Bulletin Nr. : LPdi16004
Date : 20-10-2016
Subject : 1.2 and 1.4TSi solution regarding cold start problems
System / type: LPdi

CAV.. engines

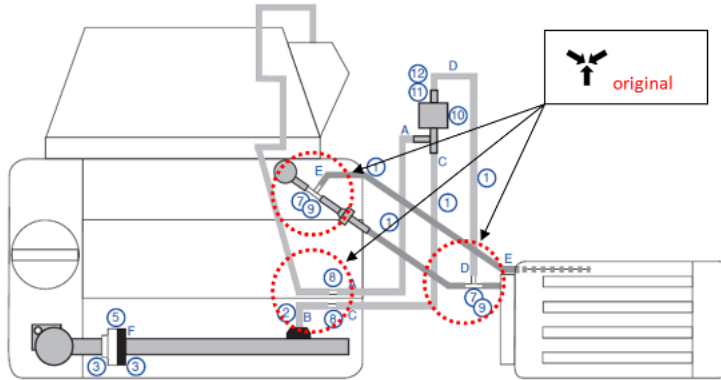
Check if the car has a modification on the crankcase ventilation system, when there is a modification set on it you have to remove the modified parts and make the connections original. The changes that are made are in the air connections and electrical on the FSU shut off valves.

Electrical connection for the CAV.. and CAX.. engine.
Remove the 3-way solenoid and make the wiring back to original.

7. New electrical connection for the power supply of shut off valve 3 “GOUT” at the FSU.

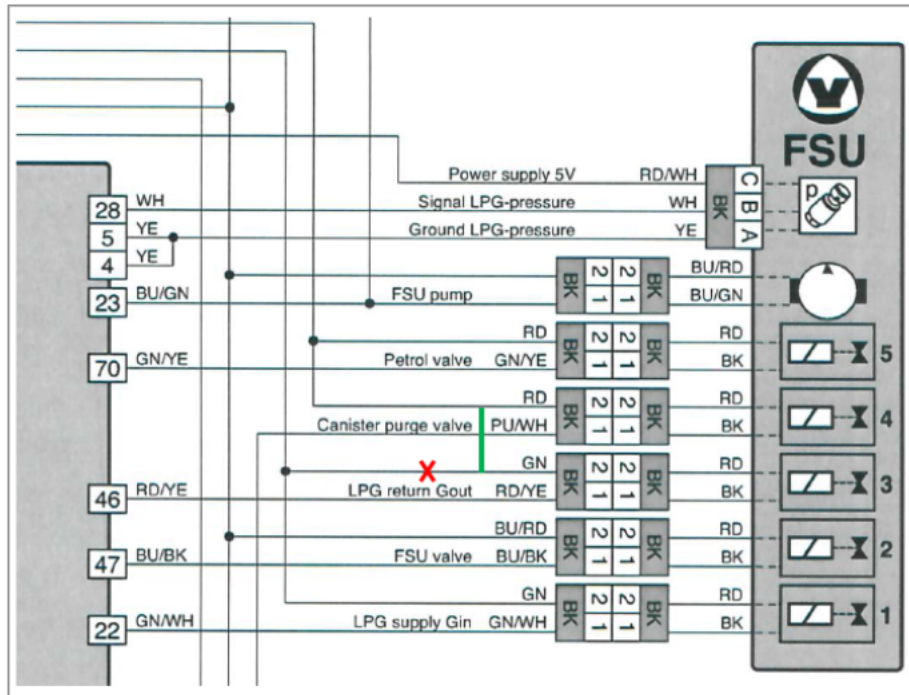
You have to cut the green wire of the 3th shut off valve on the FSU. Isolate the green wire which is coming from the LPE. The green wire which is going to the shut off valve needs to be connected parallel to the red wire of shut off valve 4.

10. Connection with interface type 207614.0-207614.3

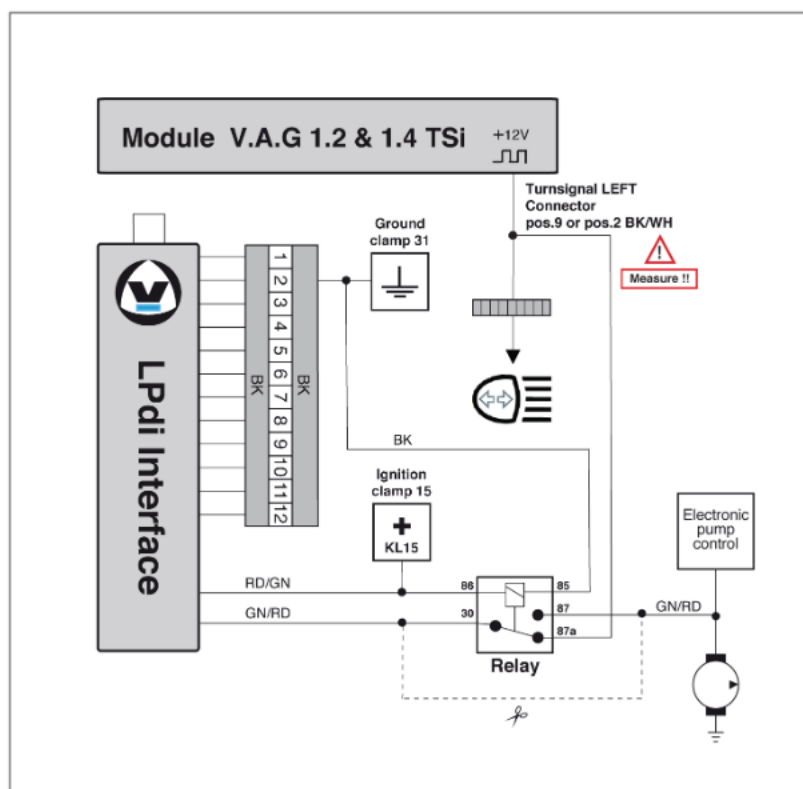
Position Relay	Function	Location	Wire
1 85	ground	pos2 (12p interface connector)	BK
2 86	+15	Wiring loom without connector	RD/GN
3 30	input interface	Wiring loom without connector	GN/RD
4 87a	Indicator light	pos9 (10p left headlight unit connector) or pos2 (2p left headlight unit connector)	BK/WT
5 87	Petrol pump control	To petrol pump	GN/RD
